## Staff Report

To: BOZAR  
From: Jessie Earley, Town Planner III  
Meeting Date: DRC, March 10, 2025  
RE: Liebl (226 Sopris Avenue), Secondary Review

**PROJECT TITLE:** Liebl (226 Sopris Avenue)

**SUMMARY:** Consideration of the application of **Denise Liebl and Todd Liebl** to site an addition at the existing contributing historic accessory building to be located at 226 Sopris Avenue, the west 75 feet of lots 1 to 5, both inclusive, except the west 12.5 feet thereof, Block 33 in the R1C zone.

e. **New windows:** Refer to GL 3.22-3.24; 3.49-3.54.

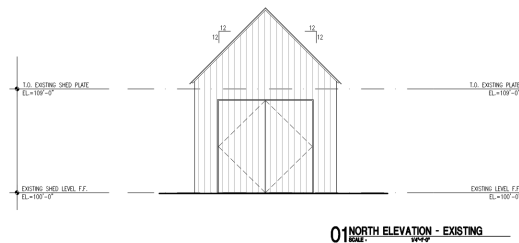
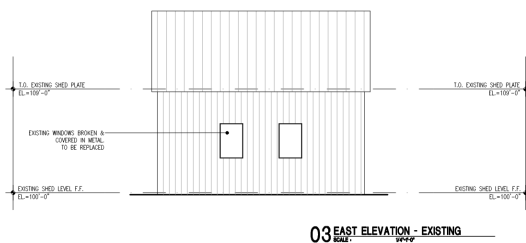
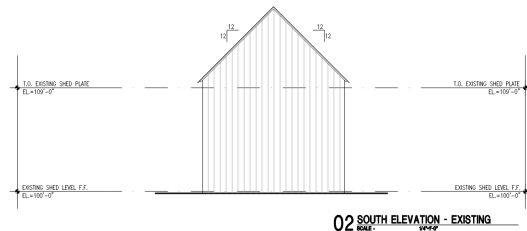
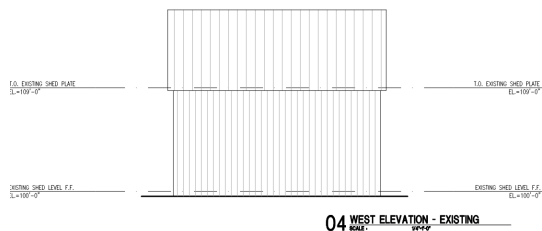
GL	Staff Analysis	DRC Recommendation
3.49 Historic windows	All historic windows must remain and be rehabilitated.	Discuss at site visit.
3.50 Position of historic windows	Windows on the historic portion of the building are to remain in existing openings. These windows are unique because they look like windows that were salvaged to put into the openings and don't fit properly. Discussion is encouraged.	Support

Plan view – Accessory Building – revised (3/10/2025 DRC)

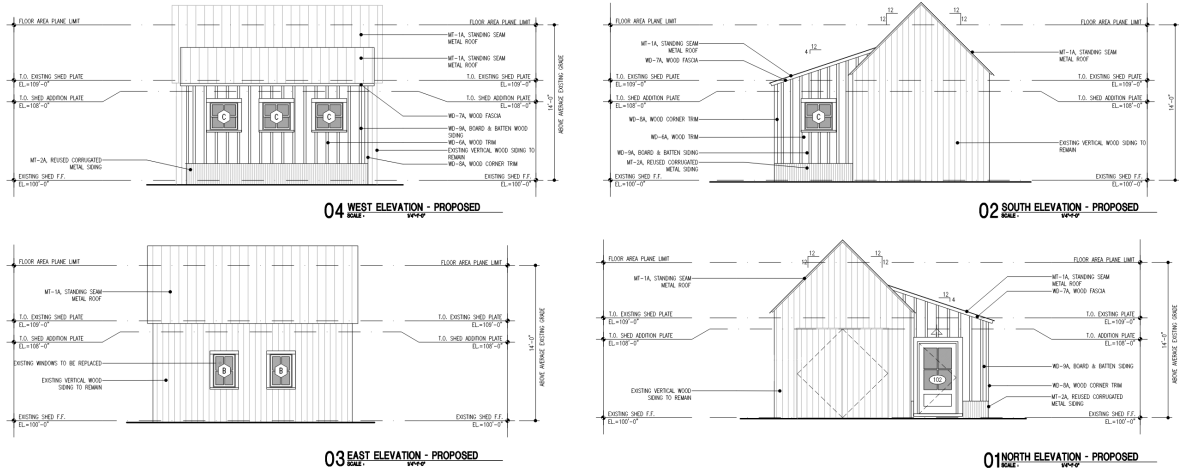
- Windows on the west elevation of the addition to the existing historic accessory building have been reduced from four to three.
- The windows on the west elevation of the addition to the existing historic accessory building have been reduced in size to be square windows.
- The three windows on the south elevation of the addition to the existing historic accessory building have been reduced from three windows to one window.
- The French doors, as proposed on the north elevation of the addition to the existing historic accessory building was revised to a single person door.

Historic AB: members noted that the amount of fenestration is contemporary. Jose suggested reducing from four to three on the west. Anderson mentioned the GL relating to 2 to 1 ratio.

### North – proposed French door (accessory building) – 1/30/2025 BOZAR

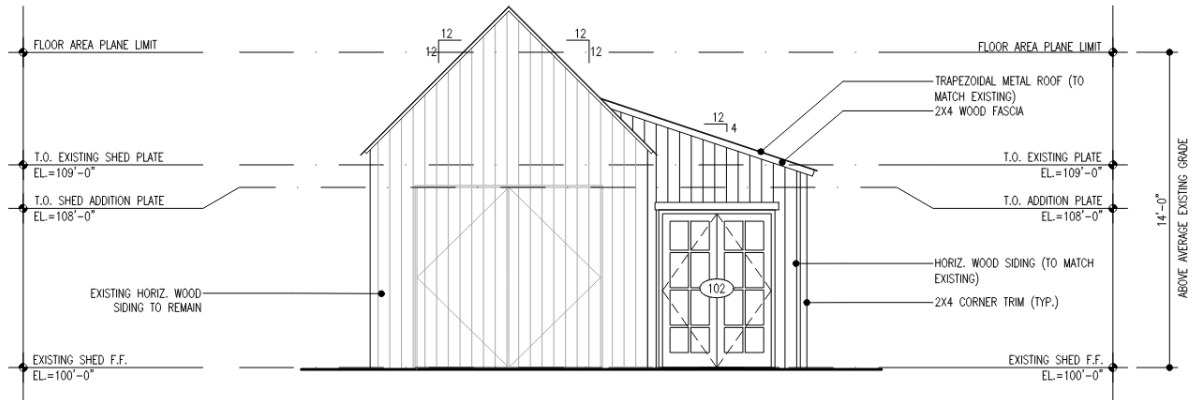
The garage door (carriage style) existing will be rehabilitated (north). **There is a wood French door proposed on the north elevation with divided lights. The door plan states that this door will be aluminum clad (red), confirmation is needed.**
